**MARRIAGE HILL
SECTION 7**

Summary of Comments on BCEO Review 7-25-13.pdf

CARRIAGE HILL SECTION 7

Sheet No. 1/15

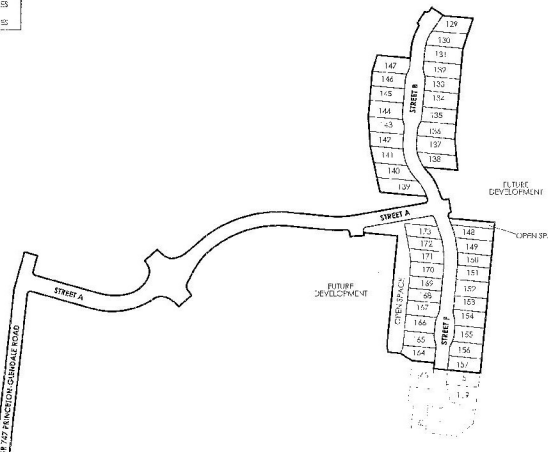
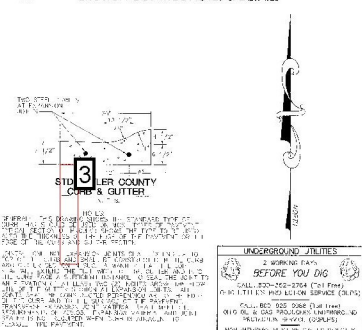
-
- ☒ Number: 1 Author: pottengere Subject: Oval Date: 7/24/2013 8:07:20 AM
I have been told by our field inspectors contractor's & owners are confused over the new Butler County typical section. Full Depth Asphalt thickness for 28' street is 9'-1'2" (6"-301, 2'-1/2"-448 & 1"-448 Surface) while Full Depth Asphalt thickness for 25' street is 8'-1/2" (6"-301, 1'-1/2"-448 & 1"-448 Surface) Each section also has an alternate gravel base section with varying asphalt thickness. Please review BC standard details and revise accordingly.
-

- ☐ Number: 2 Author: pottengere Subject: Rectangle Date: 7/24/2013 8:10:25 AM
Based upon feedback from contractors, we are willing to move the underdrain under the front edge of the roll curb. This should alleviate problems when rock is encountered and the trench is widened.
-

- ☐ Number: 3 Author: pottengere Subject: Rectangle Date: 7/24/2013 8:12:10 AM
Agreed to location for underdrain. Drain may tie into Catch basin via front face or side of structure.
-

Sheet Title	GRADING & SWPP PLAN
Project No.	04476.01
Scale	1"=50'
Sheet No.	7/15
File No.	04-476

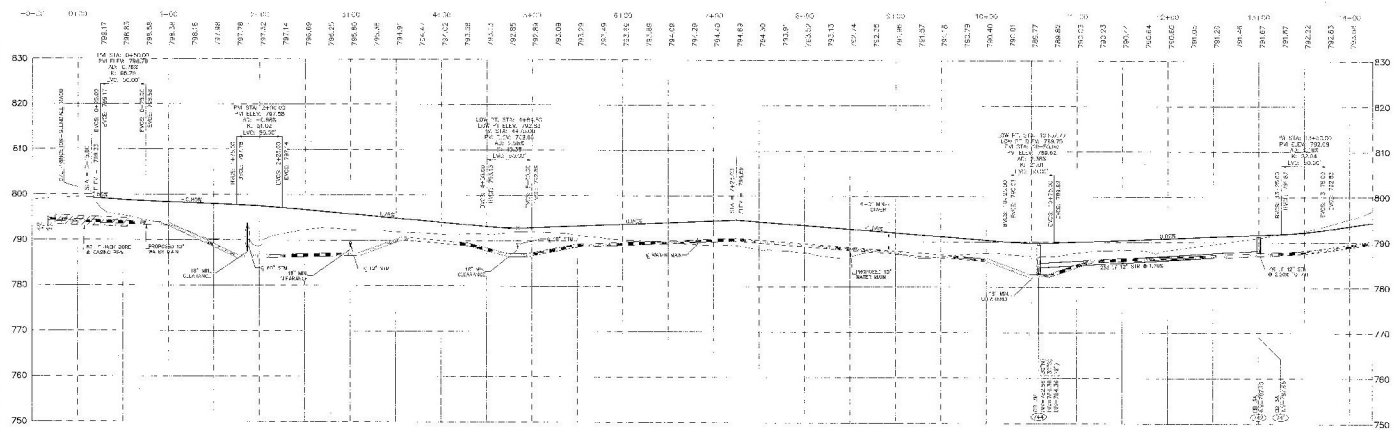
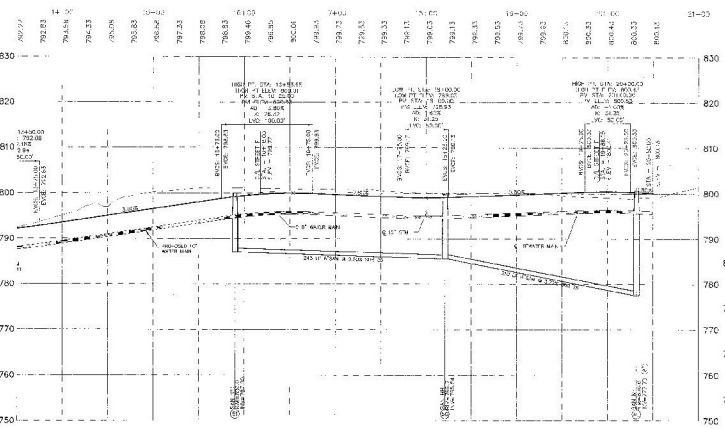
Number: 1 Author: pottengere Subject: Oval Date: 7/25/2013 2:53:15 PM
Provide additional detail on this pipe. Is this a BMP in the SWPPP? Will the inlet be protected against sediment?

Drawn by: DMT	Project No.: RA
Drawing File: 75014.DWG	Revision: 1
Reference:	NA
Date:	06/21/13
By:	DMT
Check:	DMT
Appr:	DMT
Scale:	AS NOTED
Sheet No.:	10 / 15
File No.:	04-476

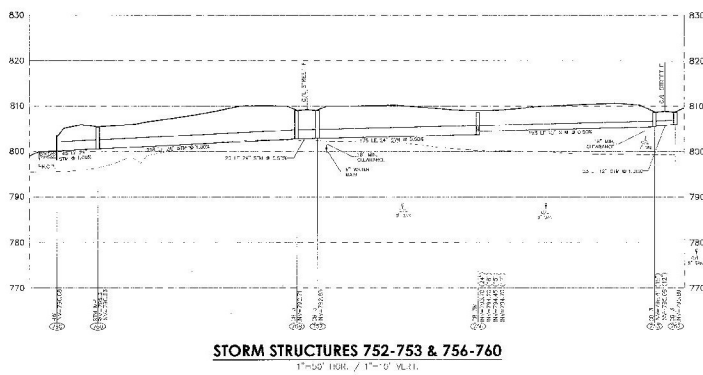
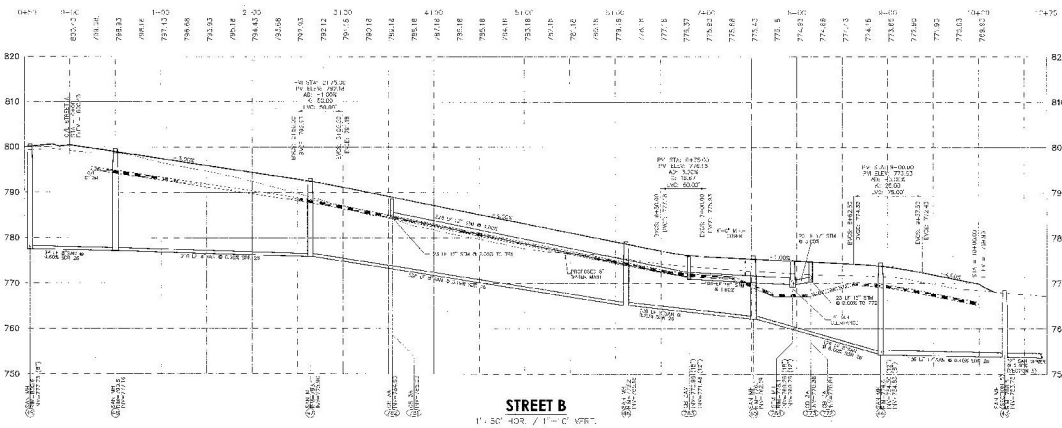
-
- Number: 1 Author: pottengere Subject: Line Date: 7/24/2013 11:08:56 AM
Shift CB and low point to this area to avoid conflicts with potential driveway, Lot 164.
-
- Number: 2 Author: pottengere Subject: Oval Date: 7/24/2013 11:14:00 AM
Provide detail of entry wall and consider pedestrian railings. This is a 9.6' vertical drop off the edge of the sidewalk.
-

Sheet Title	
INTERSECTION DETAILS	
Project No.	04476.D1
Scale	AS NOTED
Sheet No.	11/15
File No.	04-476

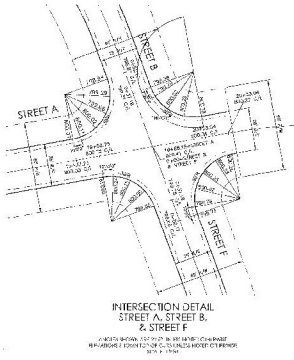
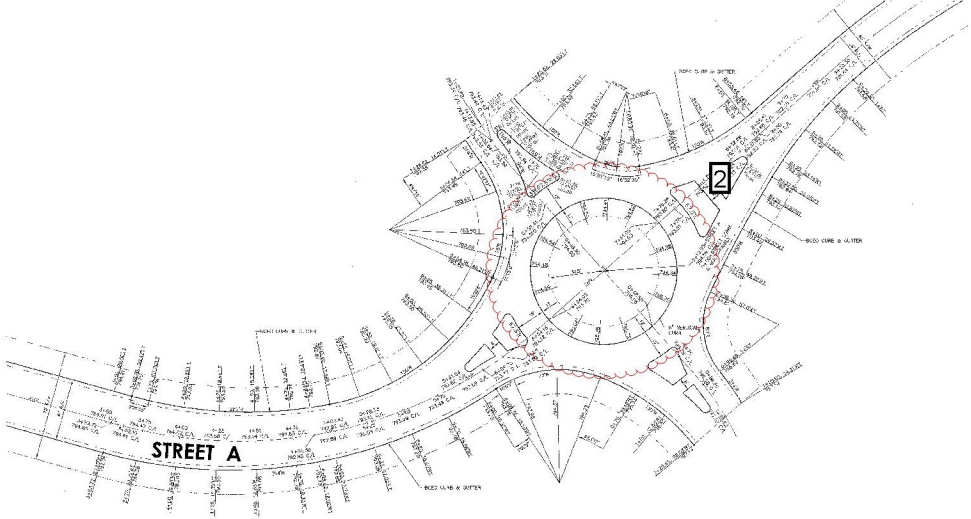
Fairly high velocity will create additional erosion problems for the receiving channel. Recommend drop manhole and additional rock protection or velocity headwall (precast headwall with dissipation blocks BCEO added to approved standards drawings)

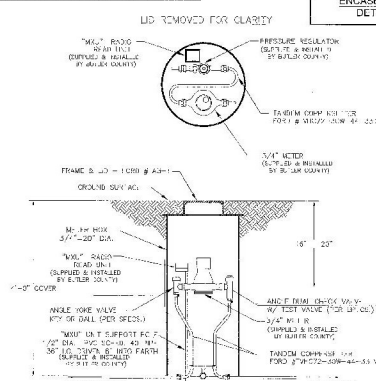
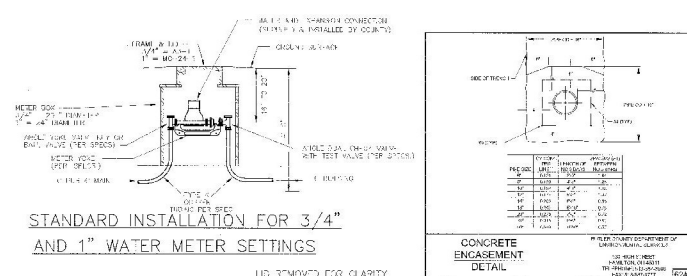
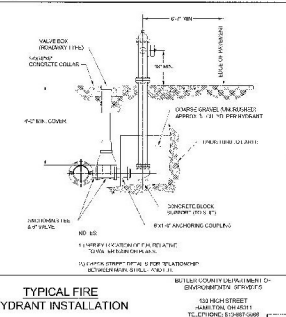
☐ Number: 1 Author: pottengere Subject: Oval Date: 7/25/2013 11:18:07 AM
Provide pavement details for Street B islands.

☐ Number: 2 Author: pottengere Subject: Oval Date: 7/24/2013 11:20:41 AM
See pavement elevation detail sheet provided by BCEO.
